Re: Docket No. CSC 461A - Greenwich Substation and Line Project, Development and Management Plan, Vol. 1, Part 1- Cos Cob Substation Modifications

**CL&P dba Eversource Energy
Docket CSC 461A - Greenwich Substation and Line
Project, Development and Management Plan, Vol. 1,
Part 1- Cos Cob Substation Modifications**

**Data Request CSC-02
Dated: 11/14/2018**

TITLE: LINE 1020 & 1703 COS COB - GREENWICH 115-kv UNDERGROUND TRANSMISSION LINE PLAN AND PROFILE STA 99+00 TO 108+00 GREENWICH, CONNECTICUT

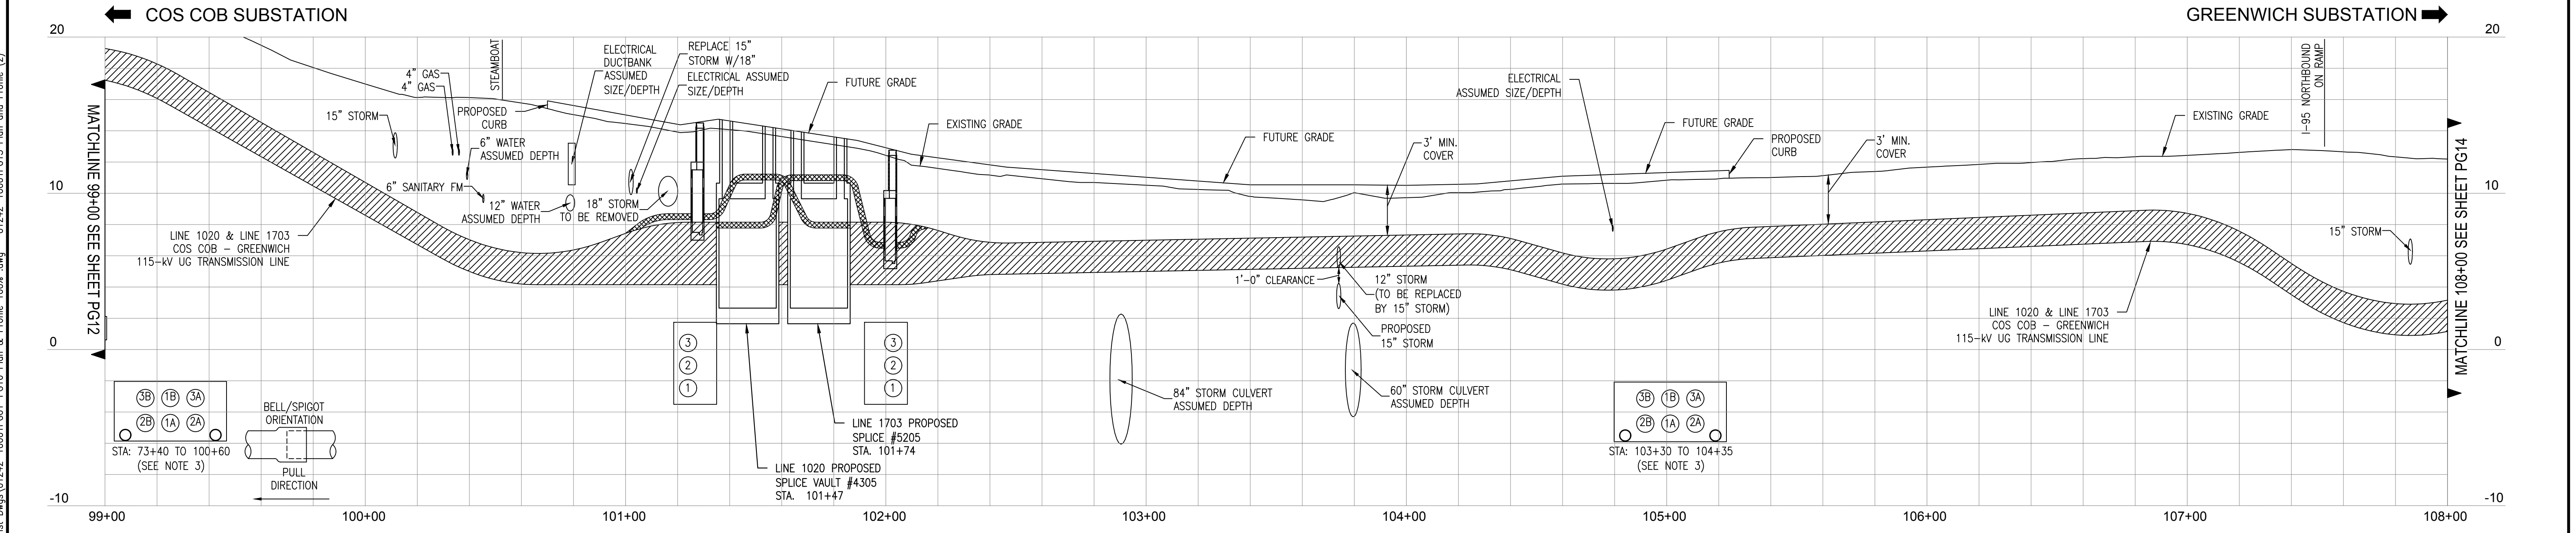
Please see the attached updated page 13 of the plan and profile drawing for the vicinity of Arch Street between Steamboat Road and Exit 3 which addresses the Town's concern.

DETOUR PLAN 1 SOUND SHORE DRIVE DETOUR

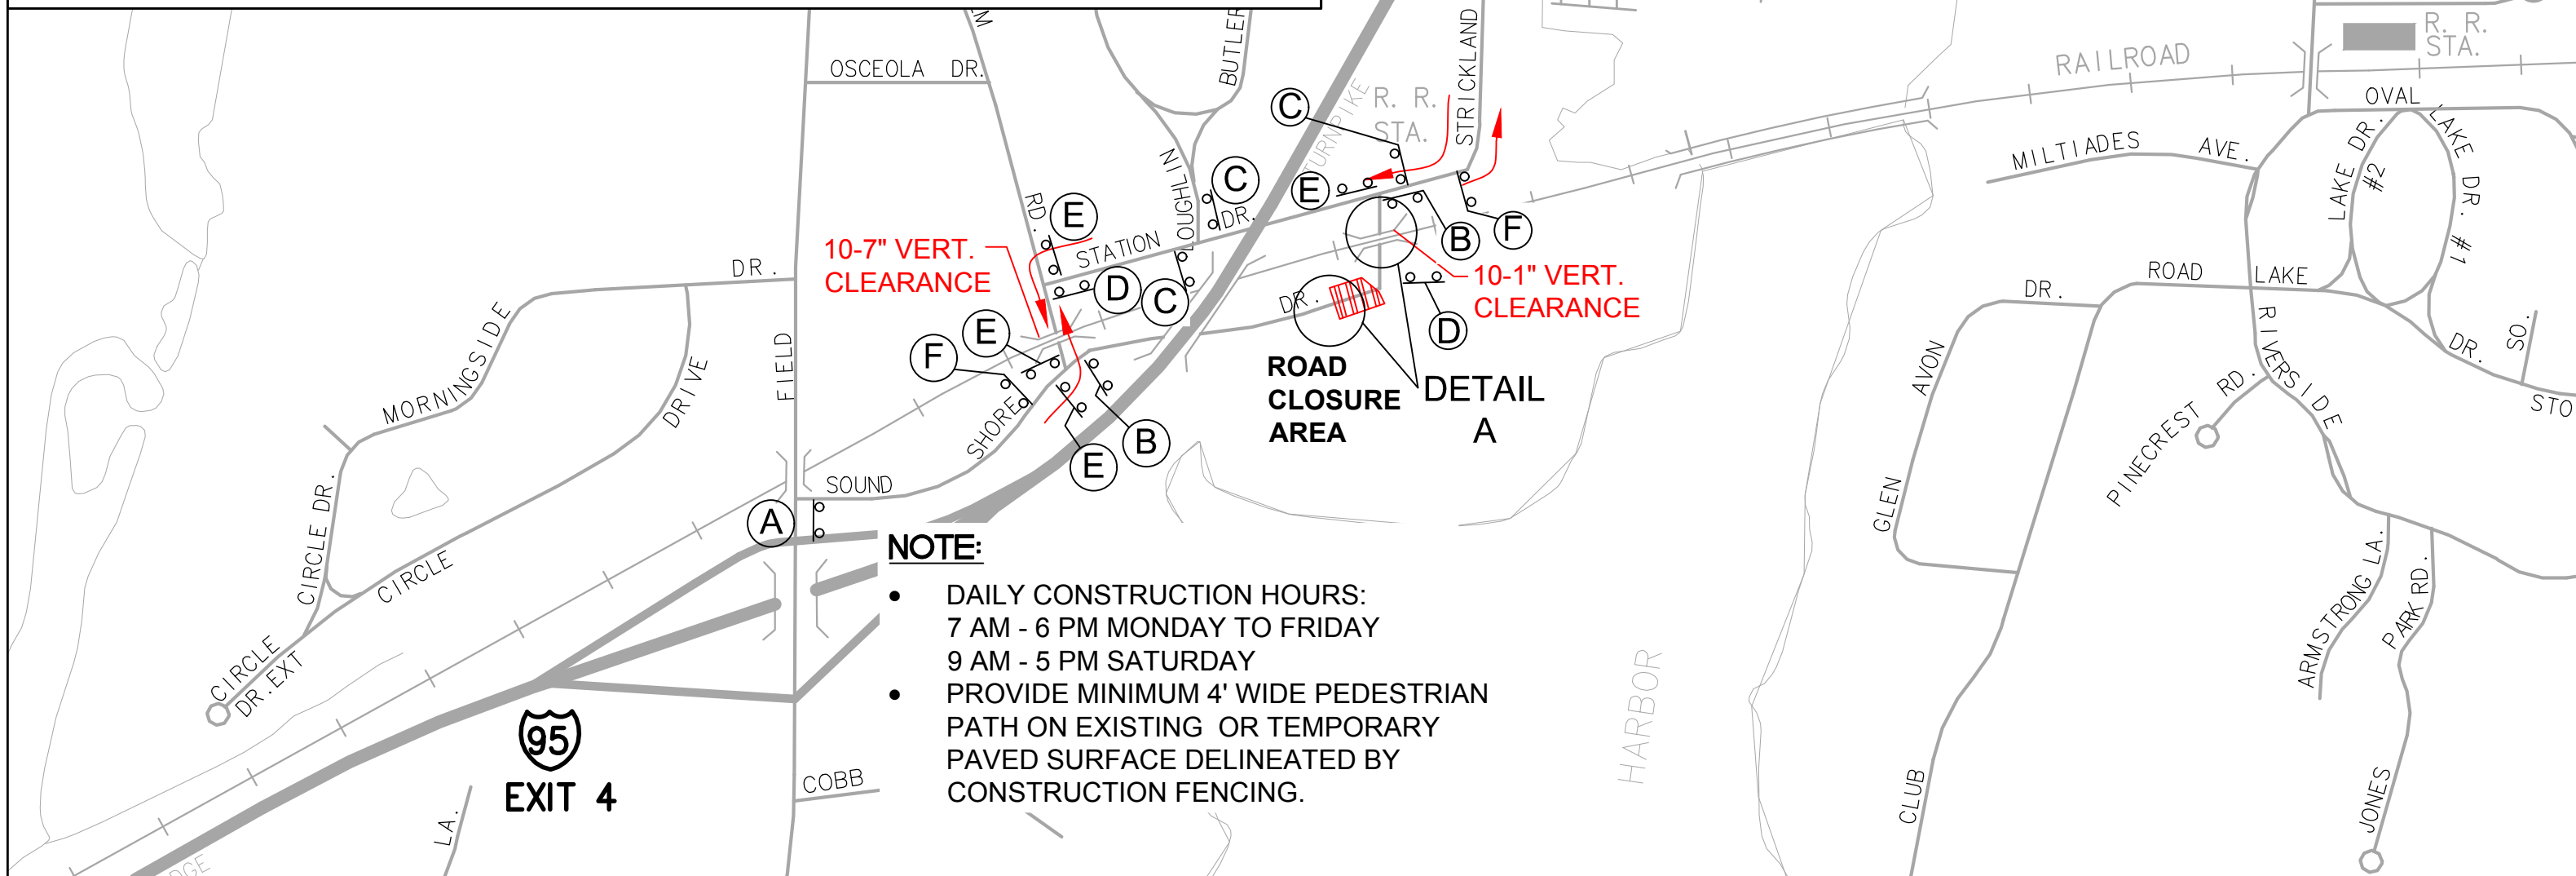
Please see the attached Detour Plan #1 has been updated to adjust the graphical polygon that depicts the road closure area to reflect that access to the Cos Cob Park shall be maintained during construction.

DETOUR PLAN 9A
MUSEUM DRIVE DETOUR
 EVERSOURCE 115 KV Underground Transmissions Facility
 From CosCob Substation To New Greenwich Substation

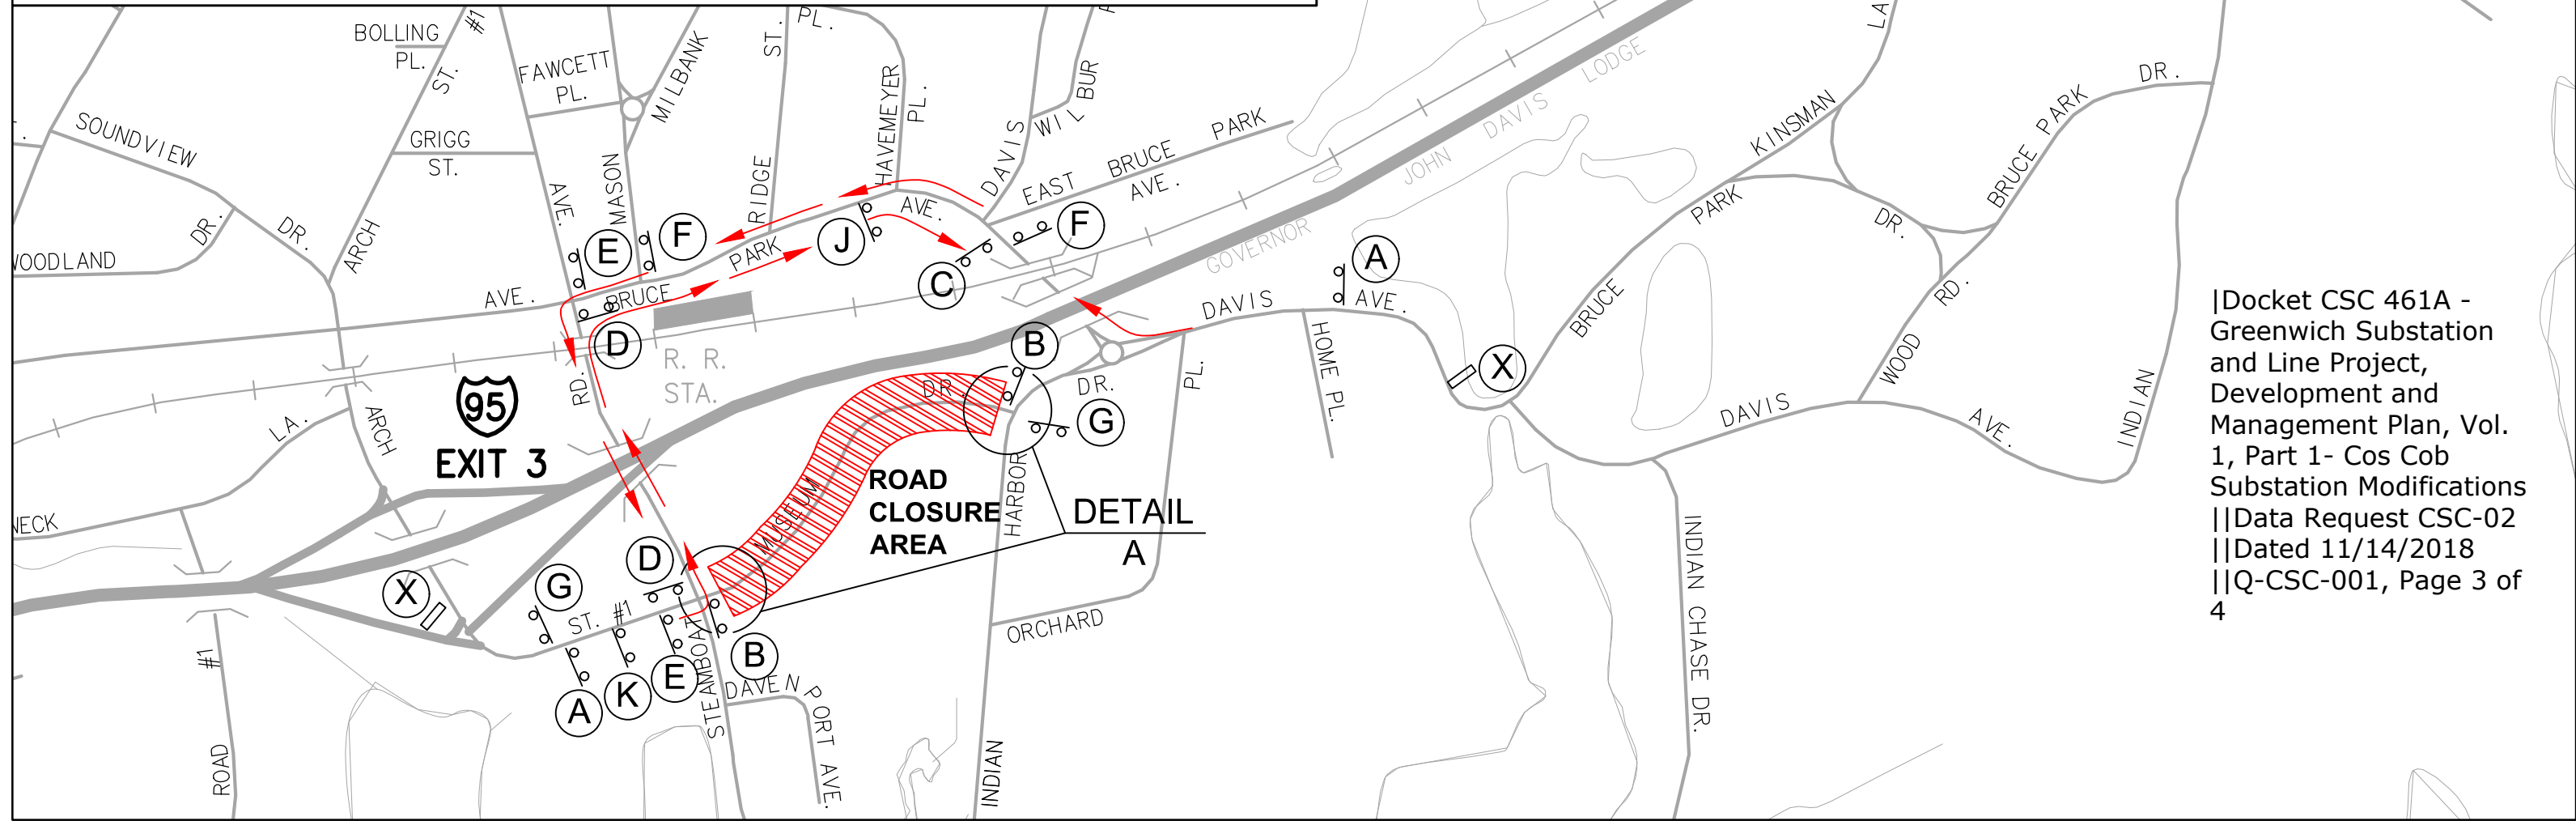
Eversource reviewed the Museum Drive working hours with the Town DPW. The Town has expressed its desire to move the permissible starting working time from 8PM to 9PM in the summer months of June, July and August on Museum Drive to allow prompt fire responder response to Bruce Park Playground. Since the Town's comments were filed, Eversource and

Please see attached Detour Plan #9A and #9B for Museum Drive which has been updated to show the travel arrows.

the Town have agreed to a solution that will maintain alternating traffic flow between the times of 8PM and 9PM during the summer months of June, July and August. Also, during these months the roadway will be closed from 9PM to 5AM. During non-summer months the roadway will be closed from 8PM to 5AM. Detour plans 9A and 9B (attached) have been updated to reflect these requirements.

SEPTEMBER TO MAY - FULL ROAD CLOSURE PERMITTED FROM 8PM TO 5AM
 JUNE TO AUGUST - ONE WAY ALTERNATING TRAFFIC SHALL BE PERMITTED 8PM TO 9PM
 FULL ROAD CLOSURE 9PM TO 5AM
